ADDITIONAL INFORMATION/TECHNICAL MODIFICATION/CORRECTION TO THE STAFF RECOMMENDATION REPORT FOR CASE NOS. DIR-2017-4167-PUB-CDP-SPP-1A; ZA-2017-3950-ZAA-1A; DIR-2017-4173-CDP-SPP-1A; AND ZA-2017-3953-CU-1A; 3813 & 3817 SOUTH ESPLANADE, 133 AND 139 HURRICANE STREET; 3913 SOUTH ESPLANADE WEST AND 128 EAST HURRICANE STREET

On August 8, 2022, the Applicant submitted updated site plans for the project: Sheet C-3A, C-13, and C-25. The updated sheets are available in the Secondary Submissions and are also included in this memo.

SHEET TITLE: PARKING LOT SITE, STRIPING & SIGNING PLAN
PROJECT: VENICE AUXILIARY PUMPING PLANT
ADDRESS: 133 HURRICANE STREET
LOS ANGELES, CALIFORNIA

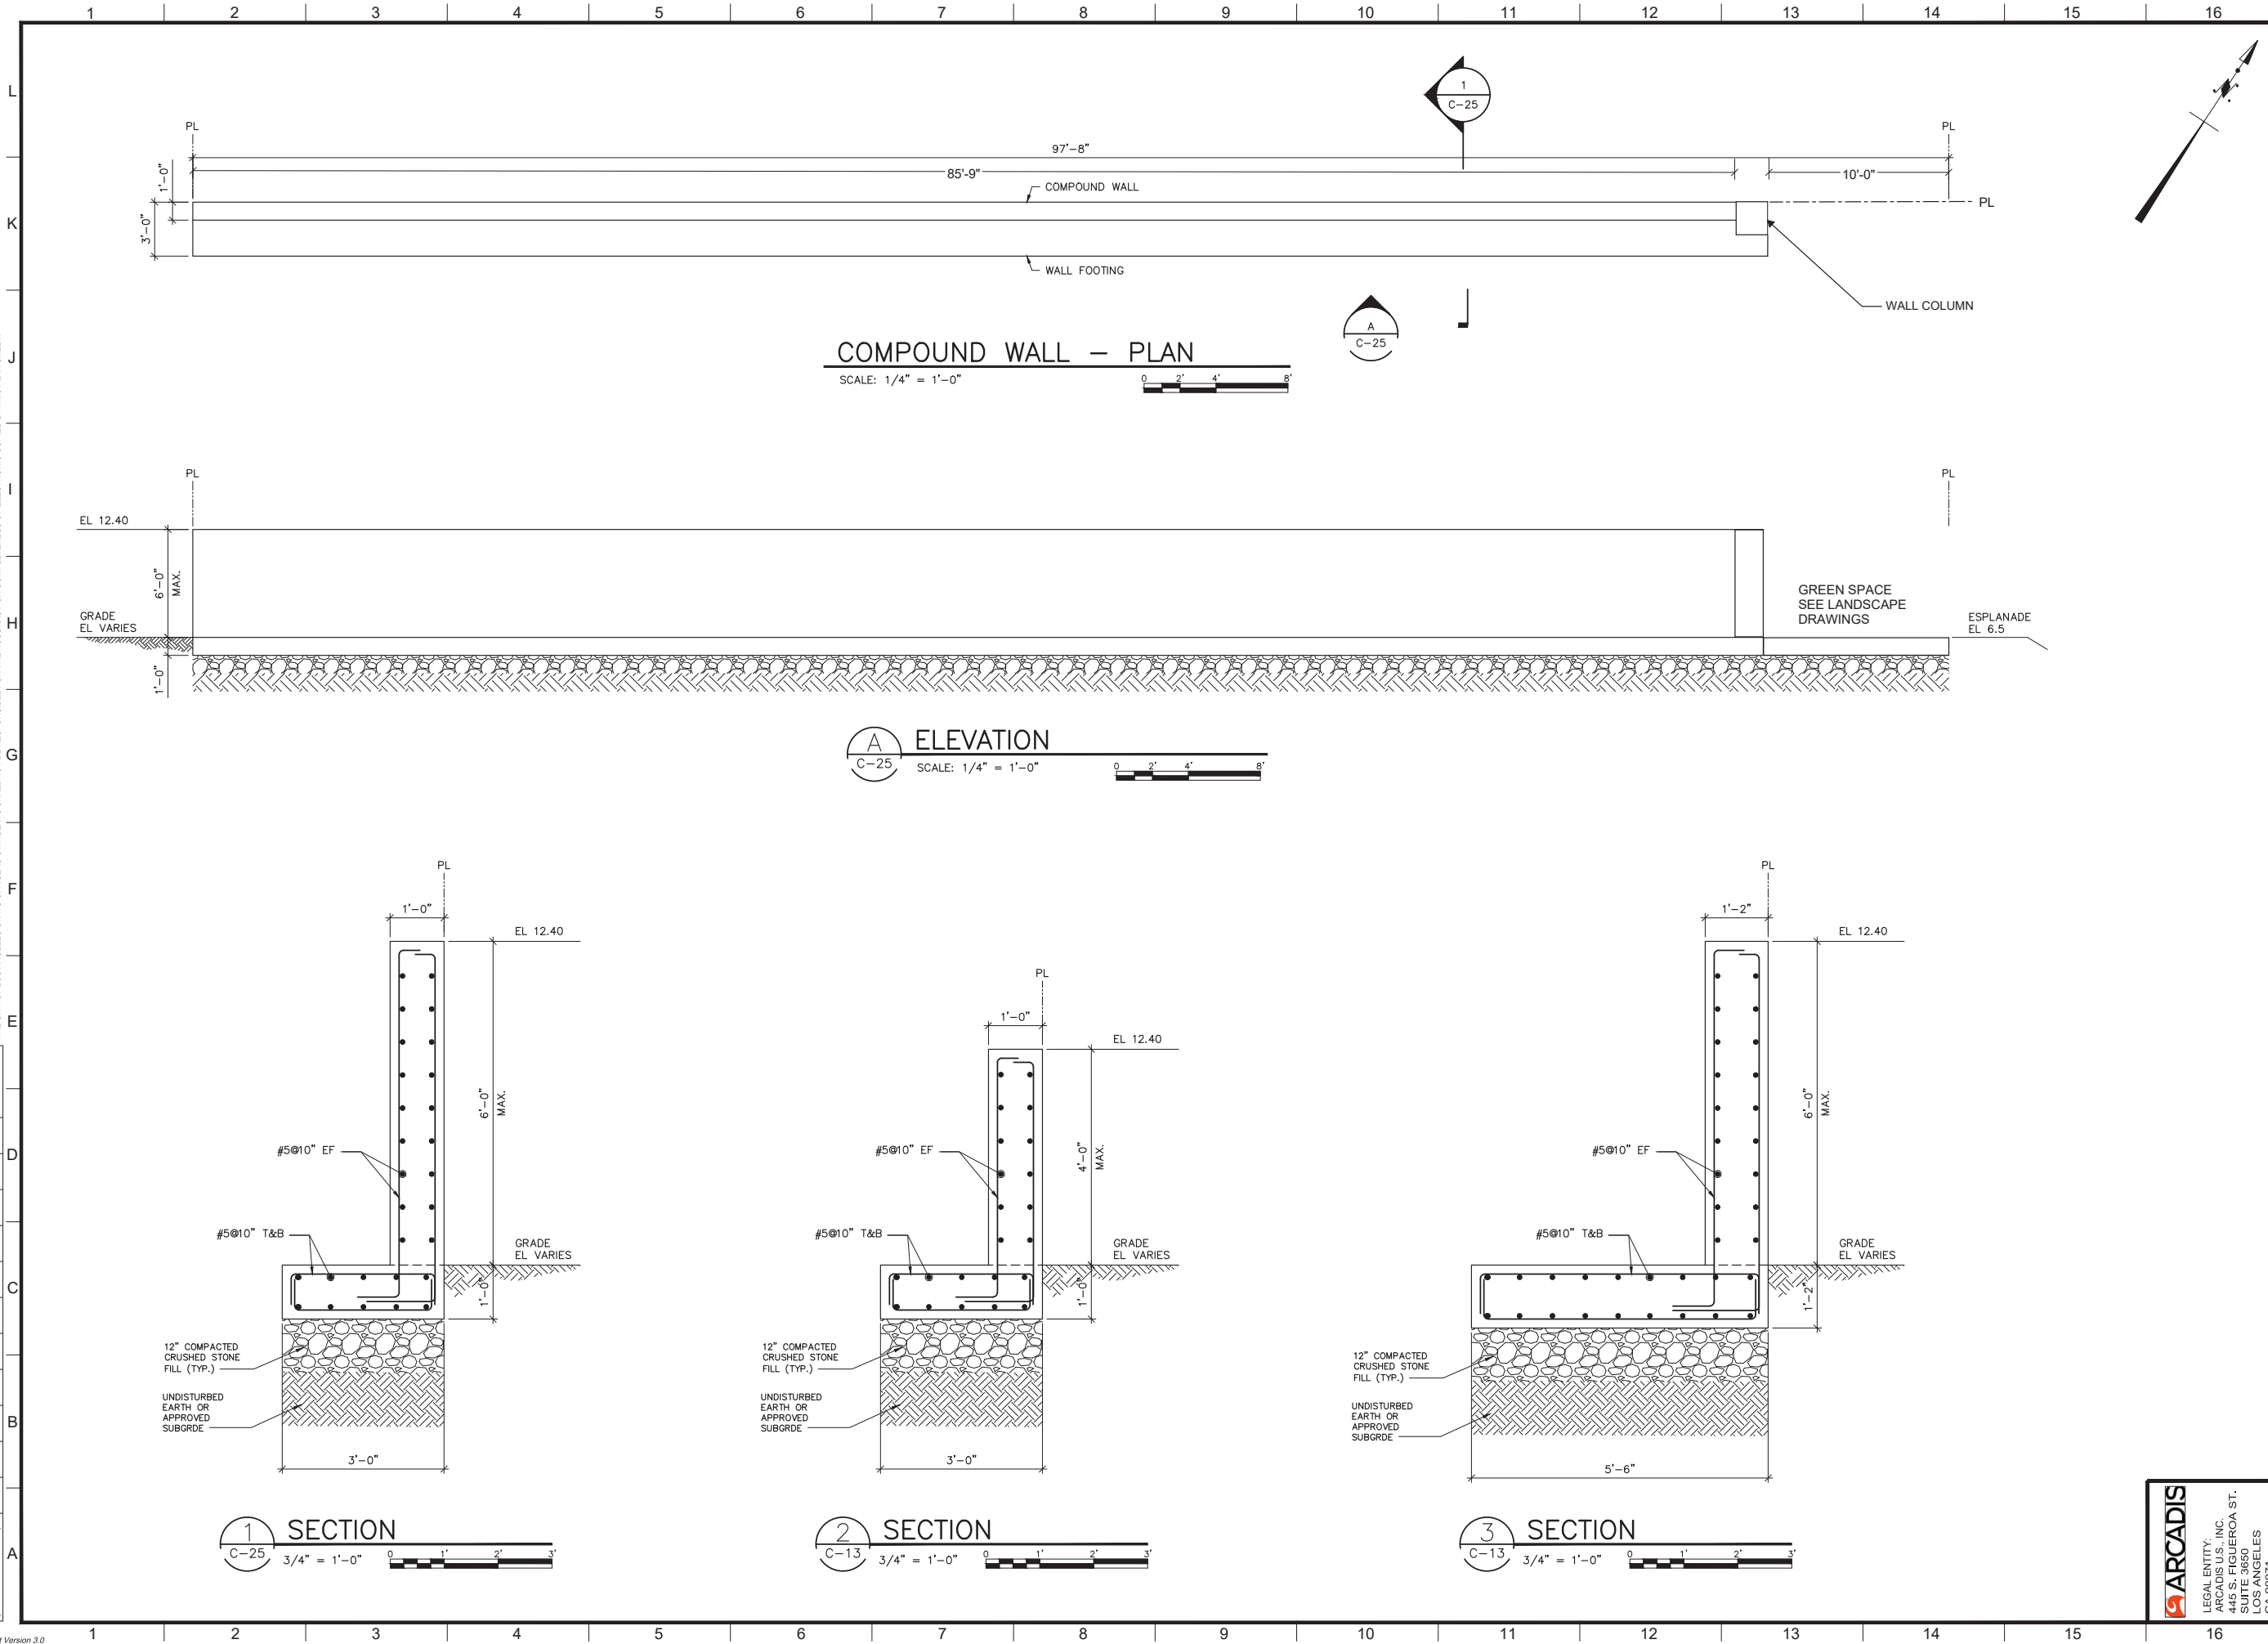
- Sheet C-3A. The updated site plan for the VAPP site shows the proposed decorative fence, located within the northern side yard, is replaced with a 6-foot-tall solid wall (concrete masonry) within the northerly side yard.
- Sheet C-13. The updated site plan for the parking lot includes a solid wall around the parking lot, as required by the LAMC.
- Sheet C-25. The new sheet shows the wall plan detail and elevation.

For Item Nos. 8-11, Planning Staff recommends the Commission include the updated and new Sheets (C-3A, C-13, and C-25) to the modified Exhibit A, attached to the staff recommendation report.
